City of Richmond Department of Planning & Development Review

PROPOSAL: Review for final location, character and extent review of a new pump station and water tank at 8850 W. Huguenot Road.

Project Name: Huguenot Water Pump Station and Tank

Re: Final Review
Huguenot Water Pump Station and Tank

Site Plan

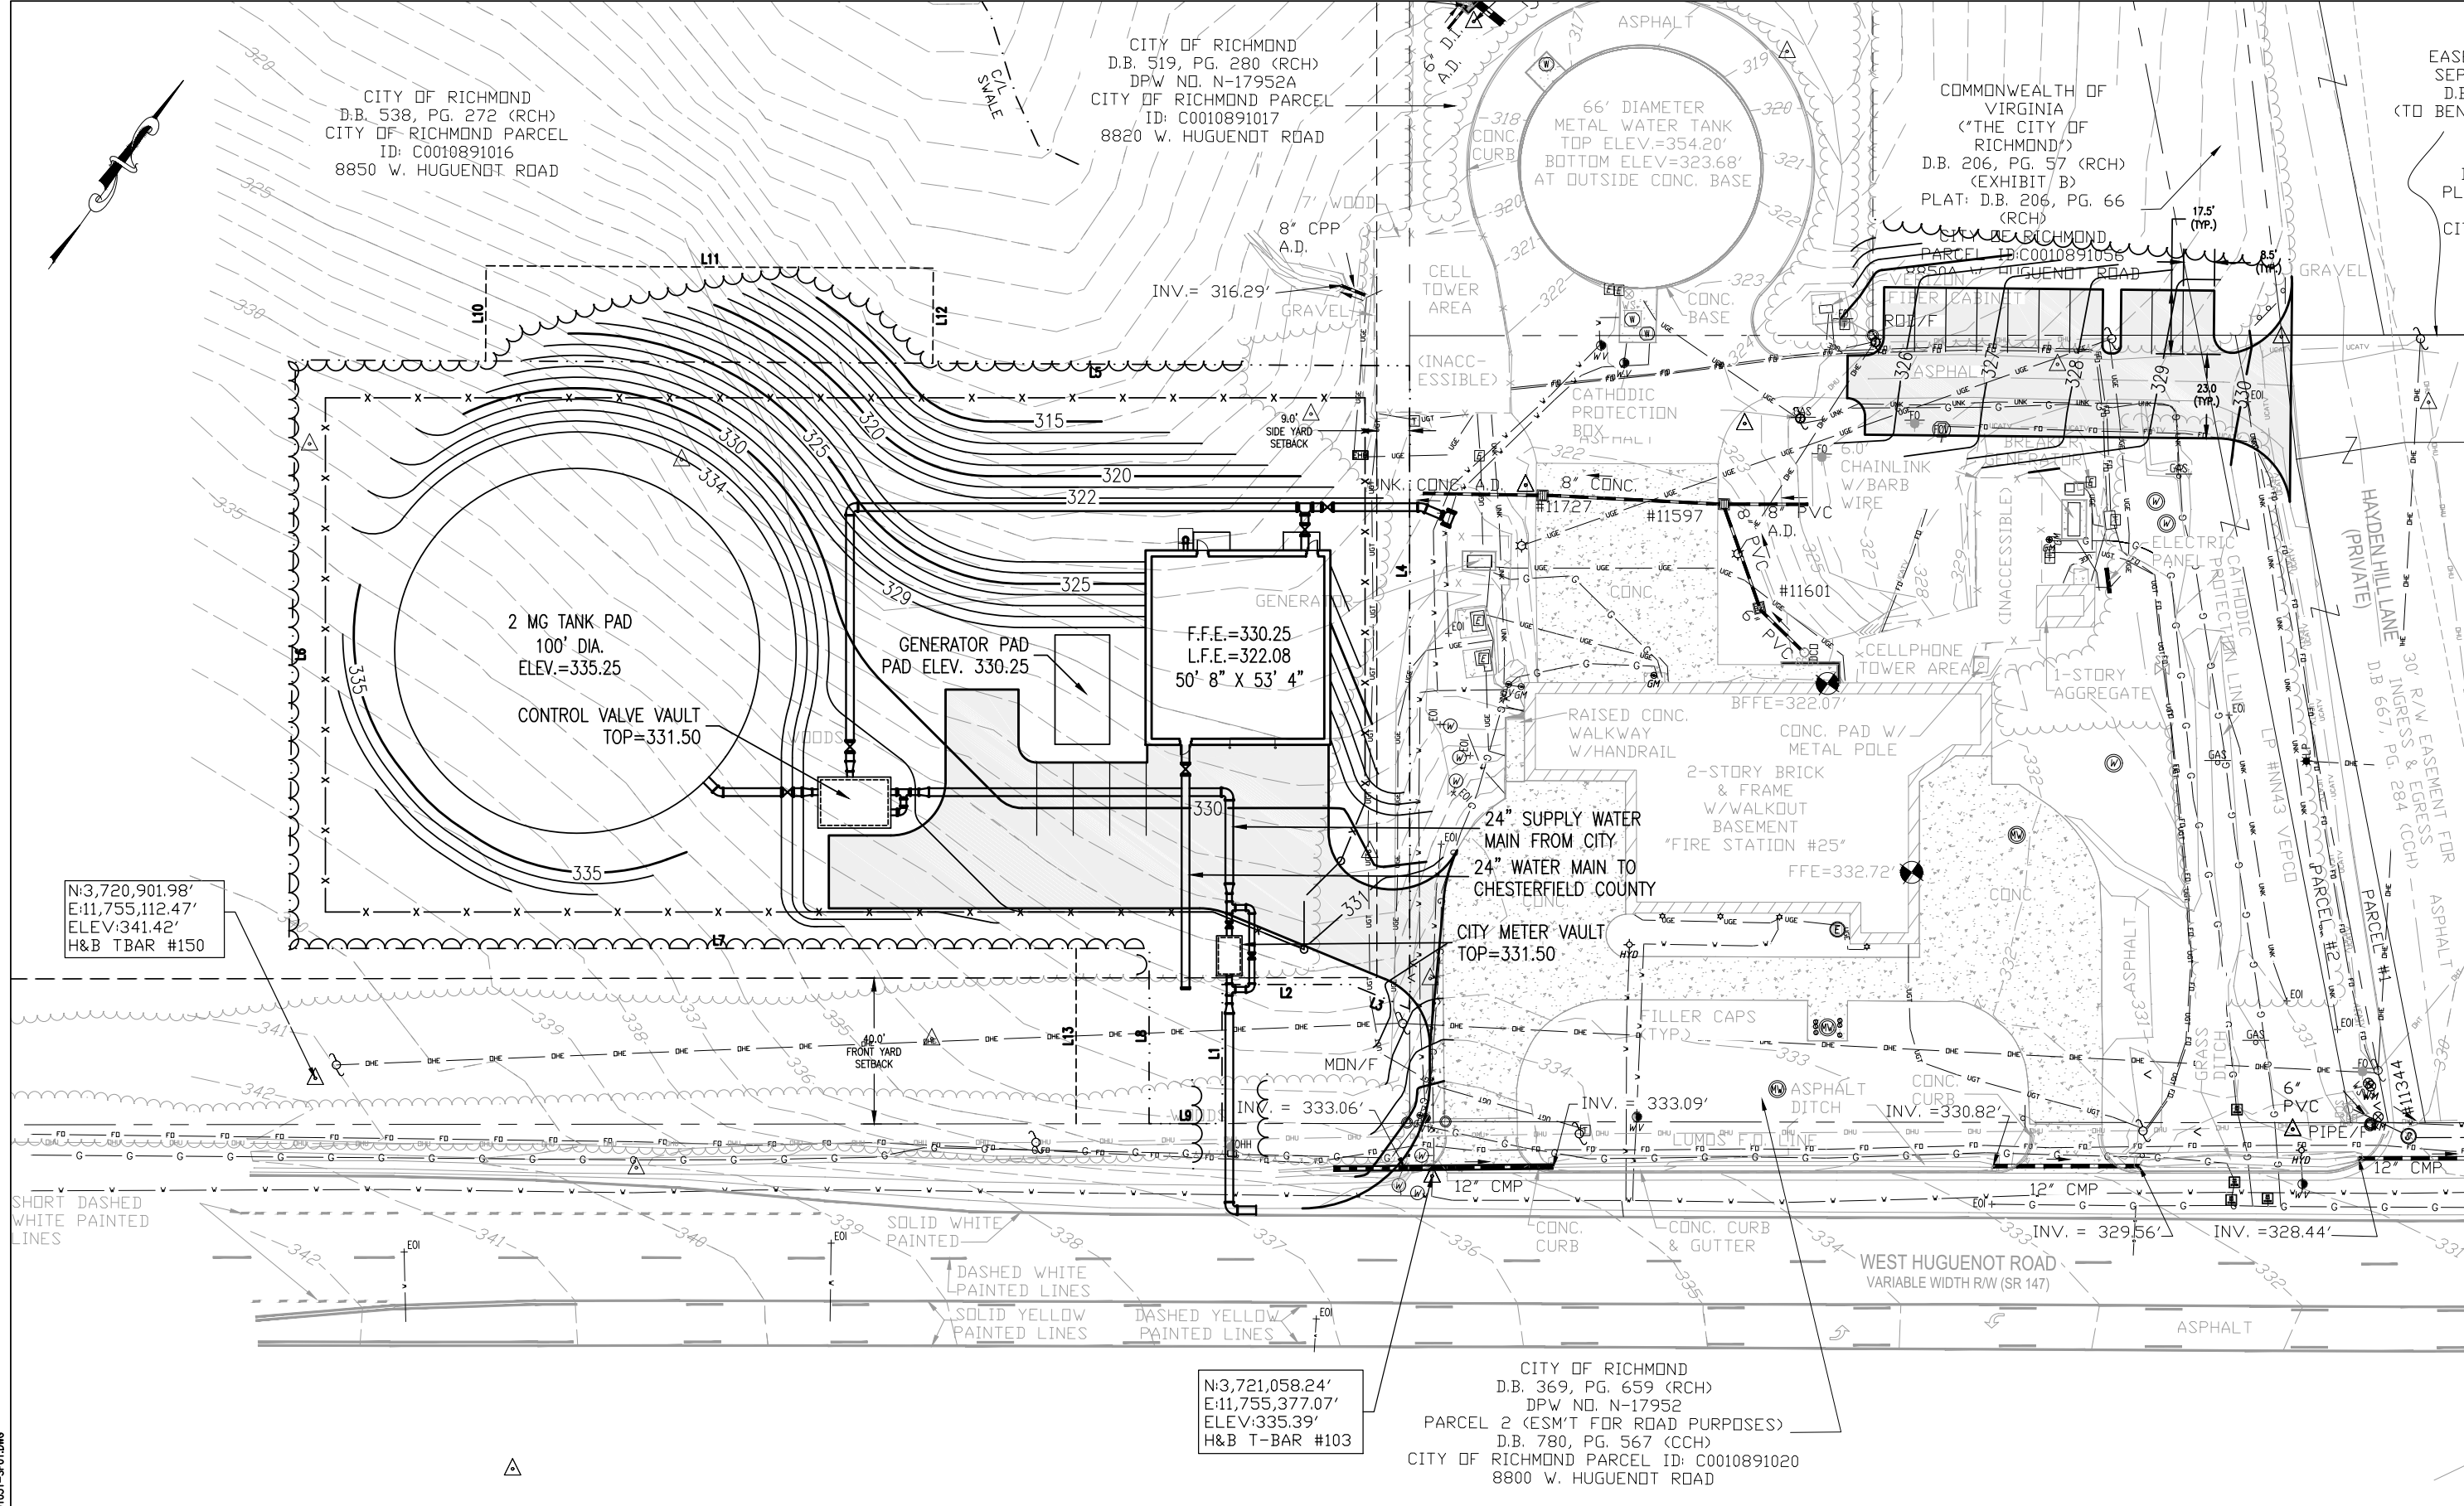
Comment 7: That the final plans include plans showing the dimensions of the tank and pump station.

Response 7: *See site plan for the tank and tank dimensions.*

Landscaping Plan

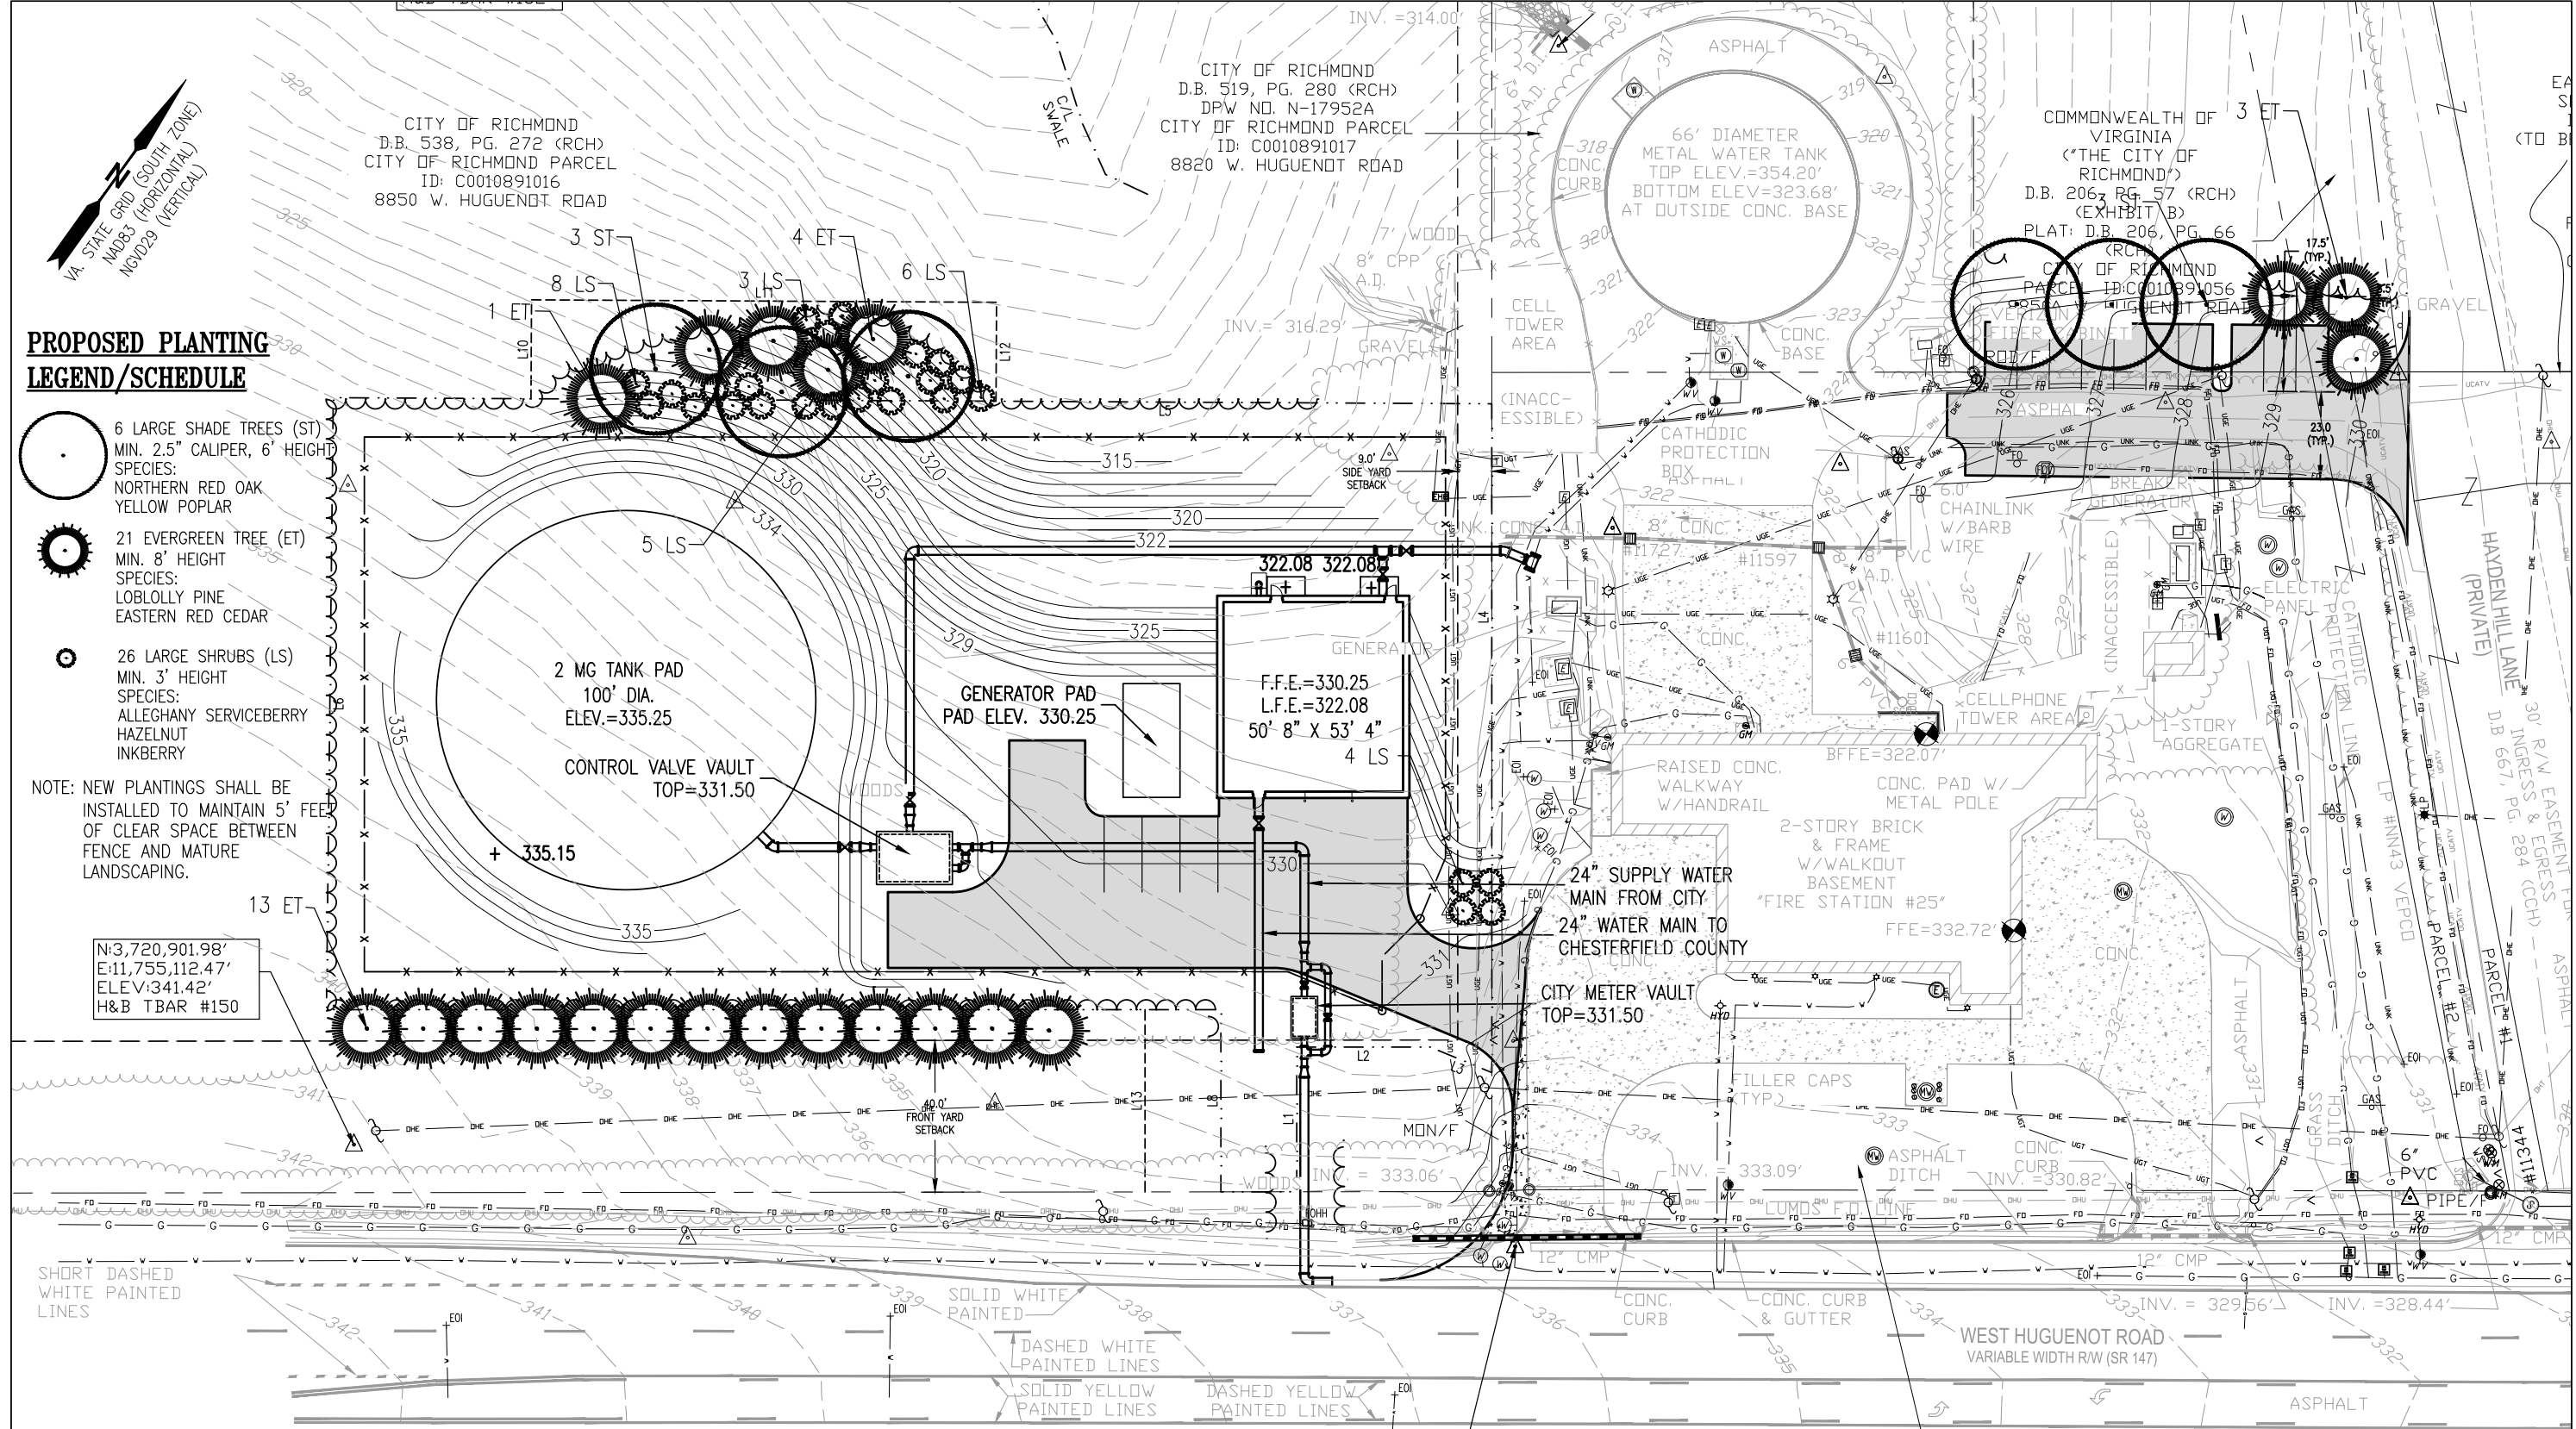
Comment 2: That the final plans include a landscape plan and schedule showing tree species, quantity, location and size at the time of installation.

Comment 3: That the applicant considers planting a row of evergreen vegetation along the Huguenot Road section of security fencing to provide year-round screening.

Response 2: *A Landscape Plan is included in the submittal.*

Response 3: *Evergreen plantings along the Huguenot Road section of fence are shown on the Landscaping Plan.*
